INNER WEST COUNCIL

DEVELOPMENT ASSESSMENT REPORT

Application No.	10.2018.121.1
Address	156 Smith Street SUMMER HILL
Proposal	Alterations and additions to an existing dwelling including the construction of a studio and pool
Date of Lodgement	2 August 2028
Applicant	Mr J P North
Owner	Mr J P North & Mrs M N North
Number of Submissions	2
Value of works	\$380,000.00
Reason for determination at Planning Panel	Heritage Item
Main Issues	Heritage/Design Landscaped Area Visual Privacy Overshadowing Stormwater
Recommendation	Approval
Attachment A	Recommended conditions of consent
Attachment B	Plans of proposed development
Attachment C	Statement of Heritage Significance

THE STUDIO ELEVATIONS

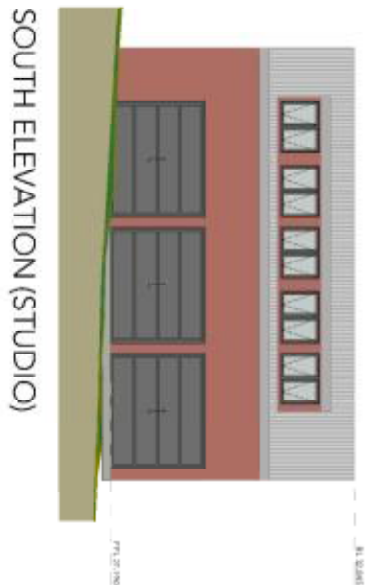
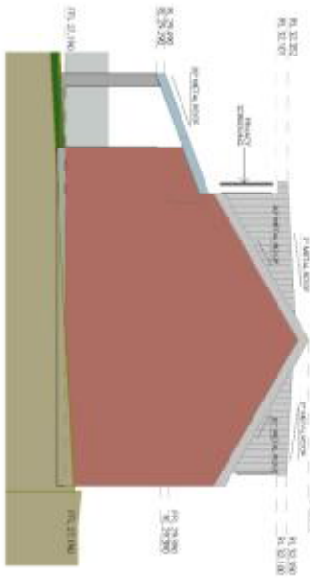
The proposed studio at the rear of the site includes a kitchen and bathroom. Given no application has been made under State Environmental Planning Policy (Affordable Housing) 2007 to the use the space as a secondary dwelling, a condition has been imposed which requires the kitchen to be deleted.

- The rear addition being amended to be a hip roof form, with an extension to the rear plane as a skillion verandah;
- The upper form of the studio/garage being amended to resemble a brick, gable-ended building from the side elevation;
- The rear lane elevation of the garage being amended to have more sympathetically proportioned garage doors with single car openings;
- The dormer windows of the studio being amended to be simple, flat roof form that align with the garage doors;
- The bulk and scale of the studio being reduced; and
- The materials and finishes of the garage/studio being amended to be corrugated steeling roofing and brick walls.

- Provide a 500mm setback between eastern property boundary and pool which contains substantial vegetation including shrubs that can achieve a height at maturity of 3 metres; and
- Delete the kitchen in the proposed studio.
